M25 Junction 10 / A3 Wisley Interchange Project - TR010030

The Secretary of State's request for comments regarding changes in replacement land provision issued on 4 November 2020

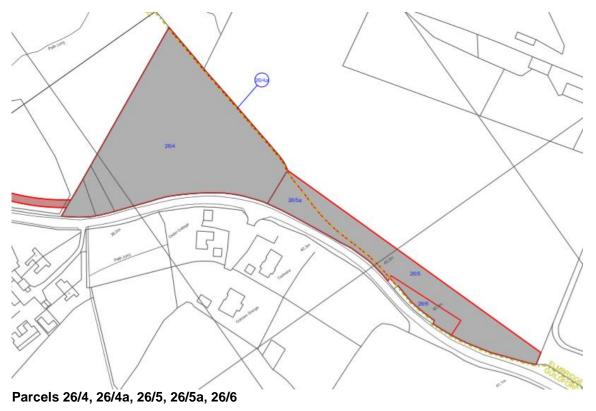
1. Removal of 26/4, 26/4a, 26/5, 26/5a, 26/6 would take away an opportunity to provide improved, safe access to Ockham Common from the direction of the hamlet of Hatchford and reduce the need for walkers and horseriders to use Old Lane for access. Old Lane can be dangerous for non-motorised users. Retention of this parcel would also provide improved opportunities for increased utilisation of the Hatchford Woods part of the site. Hatchford Woods is not part of Thames Basin Heaths SPA and increased public utilisation of this area could be beneficial in reducing the impact of recreational disturbance on ground-nesting birds in the core heathland area.

Parcels 14/1, 14/1a and 14/3

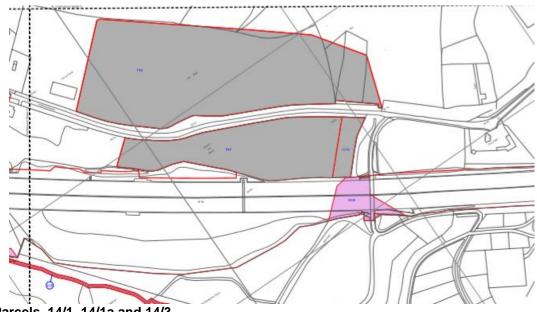
2. Removal of 14/1, 14/1a and 14/3, together with the removal of 13/9, 139b, 13/12, 13/12a poses a risk of reducing the opportunity to convey a sense to the public that there is significantly increased public accessibility around the northern part of the site. Although heavily wooded with conifers at present there is the potential to create a much more attractive landscape here which compliments the adjacent areas, and to convey a much more welcoming atmosphere. These areas are integral to the wider concept of seeking to

increase the extent of land available to the public north of the M25 and to increase linkage between the common and the wider footpath/bridleway network. The inclusion of the areas at Park Barn Farm and these areas by Pointers Road provide more opportunities for access to parts of the area whilst avoiding potential conflicts with ground-nesting birds in those parts of the site designated as part of Thames Basin Heaths SPA.

The reduction in the area of replacement land provision in the Park Farm Barn area by reducing the provision to PBF1, PBF2 and a small section of the south end of PBF3 poses a particular risk of reducing the value and 'useability' of this area by the public. The initial proposal to provide a substantial area of open access land here created an exciting opportunity to provide a valued area of open space with a varied landscape character and good linkage to public rights of way and to existing open access areas. In particular, the availability of a relatively large area of open access land north of the M25 in the Park Farm Barn area has the potential to significantly reduce pressure on the land classified as SPA to the south, by acting as a focal point for visitors coming from the Byfleet area. The land at Park Farm Barn also provides good opportunities for biodiversity enhancement. There is existing biodiversity interest in the open grassland, which the applicant has undertaken to maintain, and there are further opportunities to enhance the ecological value of the areas of woodland here.
